Access Compliance Report

Public Rights-of-Way

(Curb Ramps)

Intersection ID: 44032	Main Street: ROZZELLES_FERRY_RD	Cross Street: DUNN_COMMONS_PY	Location: NE
ADA ID: 00318FE94AED	Ramp Type: PerpDiag	Initial Pass/Fail: Fail	Overall Compliance: No
		Severity Score: 22.5

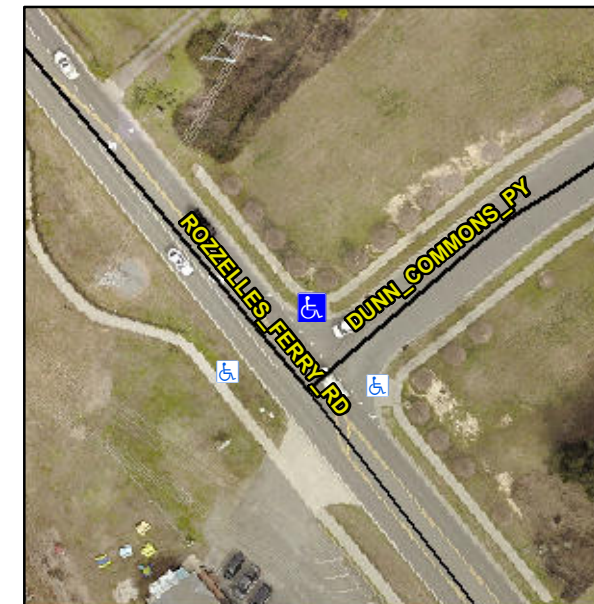
Not Found, R304.5.1, R304.2.2, R304.5.3

Compliance	Description	Data	Compliance	Description	Data
N/A	Ramp Length (in)	75.0	No	Ramp Slope (%)	8.4
No	Ramp Width (in)	47.0	No	Ramp XSlope (%)	4.2
N/A	Flare Type LT	N/A	N/A	Flare Type RT	N/A
N/A	Flare Slope LT (%)	N/A	N/A	Flare Slope RT (%)	N/A
N/A	Flare Traversable LT?	N/A	N/A	Flare Traversable RT?	N/A
N/A	Landing Length (in)	N/A	N/A	DWS Provided?	N/A
N/A	Landing Width (in)	N/A	N/A	DWS Contrast?	N/A
N/A	Landing Slope (%)	N/A	N/A	DWS Length (in)	N/A
N/A	Landing X Slope (%)	N/A	N/A	DWS Full Width?	N/A
N/A	Landing Curb? (Y/N)	N/A	N/A	DWS Offset (in)	N/A
N/A	Shared Landing?	N/A			
N/A	Gutter Ponding?	N/A	N/A	Gutter Slope (%)	N/A
N/A	Gutter Lip Ht (in)	N/A	N/A	Gutter X Slope (%)	N/A
N/A	Painted X Walk1?	No	N/A	Painted X Walk2?	No
	X Walk 1 Direction	To NW		X Walk 2 Direction	To SW
N/A	X Walk 1 Width (in)	N/A	N/A	X Walk 2 Width (in)	N/A
	X Walk 1 Slope (%)	3.6		X Walk 2 Slope (%)	1.6
	X Walk 1 X Slope (%)	1.4		X Walk 2 X Slope (%)	0.5

Remove & Replace Curb Ramp With Two New Directional Ramps or Equivalent.
